Wellington City Proposed District Plan

Hearing Stream 4

Part 5: Mixed Use Zone

Section 42A of the Resource Management Act

Proposed Zone Changes for 10 Surrey St, Tawa

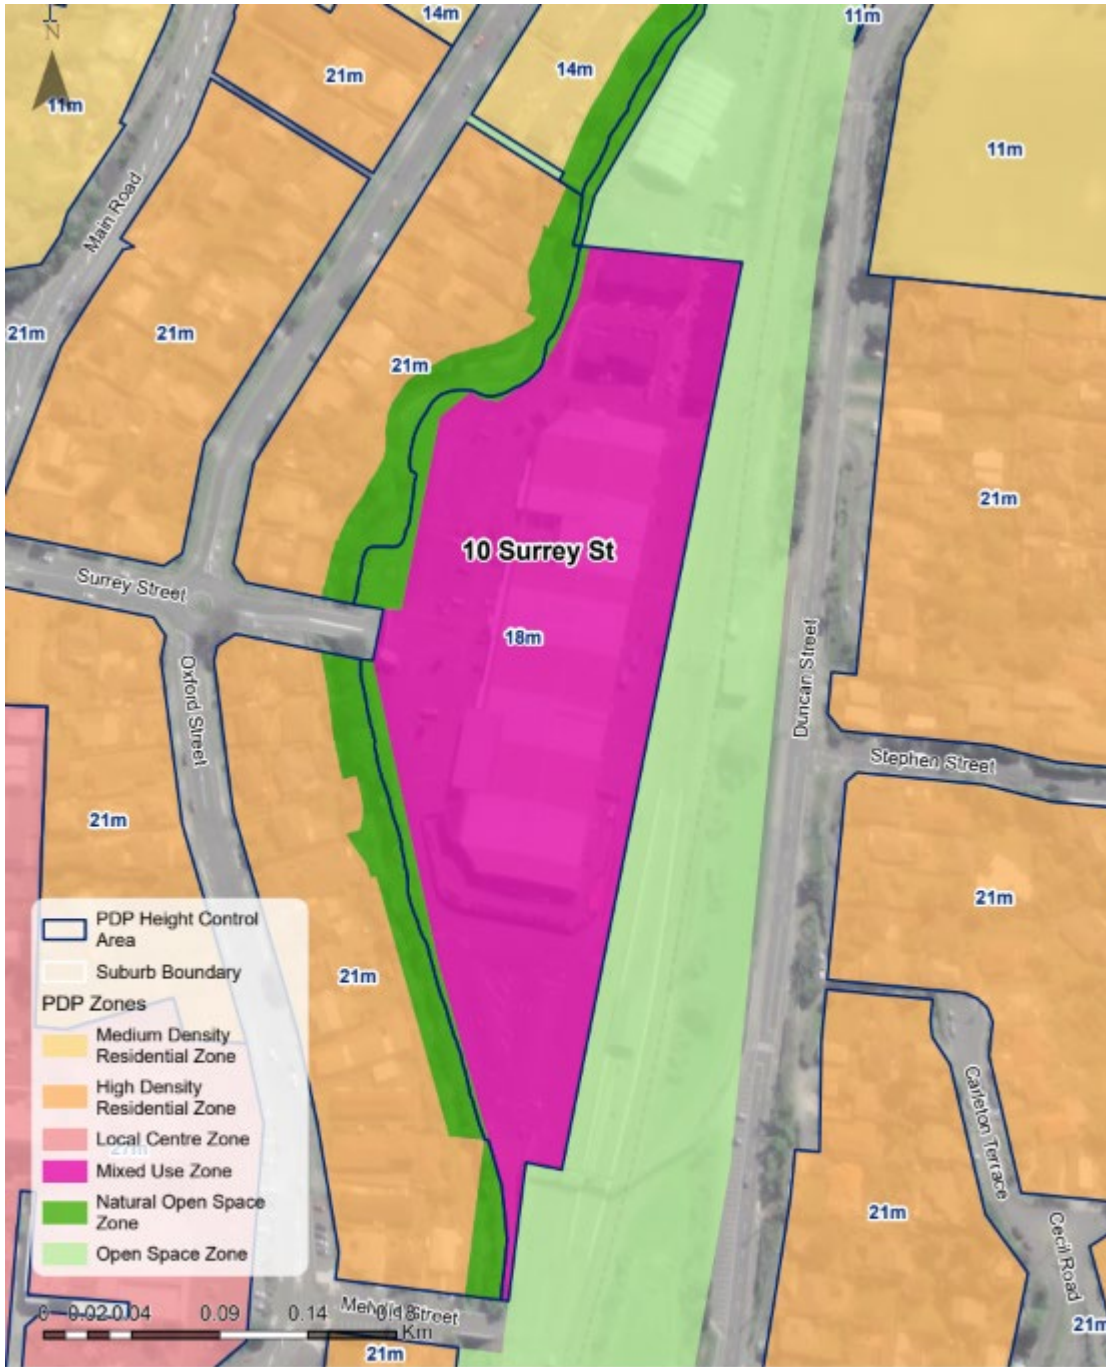
206. I agree with Tawa Business Group [107.19] and Wakefield Property Holdings Limited [108.1] that the site at 10 Surrey Street (Tawa Junction) is an appropriate location for increased building height. MUZ-S1 sets a building height of 15 metres but allows for up to 22 metres on this site where a development contains residential activity. This site is bounded by the railway corridor to the east and otherwise by HRZ, which has a 21 metre height limit. Given this context, I recommend that Tawa Junction is moved to Height Control Area 4 at MUZ-S1 (18 metres). A map showing this change is provided at Appendix 1 of this report (Part 5, Mixed Use Zone). No change to MUZ-S2 is required.
